Site Plan Review

Site: 27601 Southfield Road
Applicant: Oakland Development, LLC
Plan Date: November 3, 2025
Zoning: VC Village Center District
Parcel ID: 24-14-432-010
Proposal: Commercial Site Plan Update

Proposed Delivery Space Layout (10' x 40')

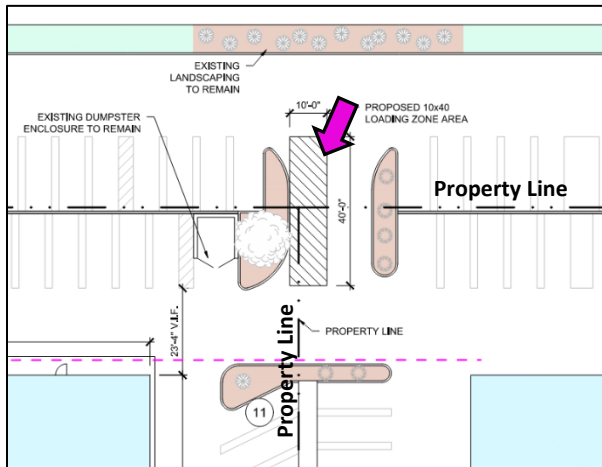
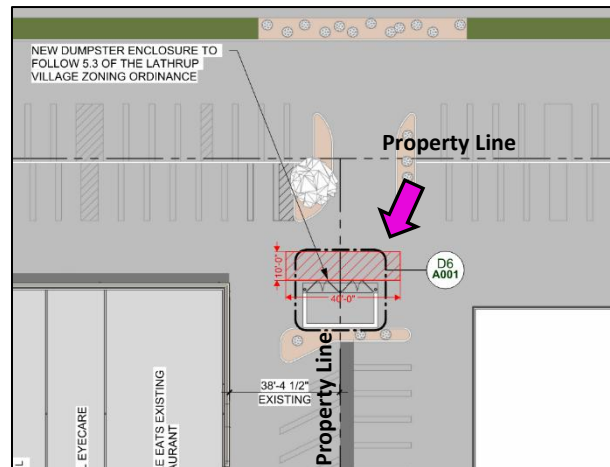
The site plan identifies the designated 10' x 40' loading zone straddling the property line between the subject site and the northern adjacent site, under common ownership of the applicant. As stated above, ordinance-required loading zones shall be independent and unobstructive to driveways, drive aisles, and parking spaces. The Planning Commission may wish to discuss the proposed location of the required loading zone, which is shown to partially obstruct drive aisles and access to the existing dumpster pad. We note that when the loading zone is occupied, the vehicular circulation of the combined sites does not appear to be hindered. No vehicle shall obstruct the the dumpsters during times of waste pick-up.
